## Product release notification

### ADI 3M release to replace ADB 3M & ADB 3M Kit

ADI 3M

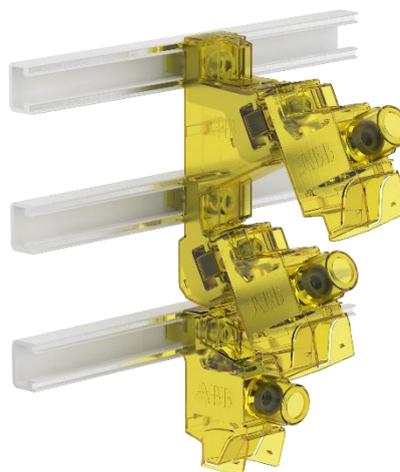
We are happy to announce the launch of the new ADI 3M that will replace the ADB 3M & ADB 3M Kit. ADI 3M will be sold as a separate unit where standard ADI 300 connectors are added separately.

- The old ADB 3M was tested for 500A. The new ADI 3M is now tested for rated operational current of 630A, which releases the full potential from ADI 300.
- When using the old ADB 3M the nuts from AD 300 had to be removed. With ADI 3M the ADI 300 connector can be directly installed without any modification, which makes installation easier and quicker.
- ADI 3M has a transparent design that goes in line with the rest of the Kabeldon fusegear and connectors. The transparency also makes the connections to busbar visible and clear.
